**CITY OF AUSTIN – DEVELOPMENT SERVICES DEPARTMENT  
SITE PLAN APPLICATION – MASTER COMMENT REPORT**

CASE NUMBER: SP-2019-0297C  
REVISION #: 00  
CASE MANAGER: Renee Johns

PROJECT NAME: 218 South Lamar  
LOCATION: 218 S LAMAR BLVD SB /W UNITS

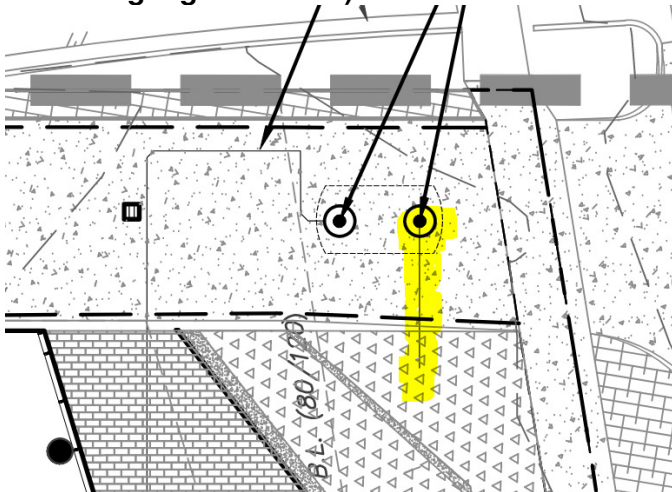
IW2. Show all private plumbing lines associated with the installation location of the exterior grease interceptor.

**U3: Comment stands. The proposed private plumbing lines are not in compliance with plumbing code requirements. Specifically, the inlet and outlet pipes are not identified, and either the inlet or outlet line ends in a landscaped area. Additionally, the pipe that ends in a landscaped area is shown connecting to the side of the interceptor, but the inlet and outlet pipes must connect to each respective end of the grease interceptor (see highlighted areas).**

Response: The private plumbing lines serving the exterior grease interceptor have been added to the Utility Plan Sheet (Sheet 18). Please see the revised plans.
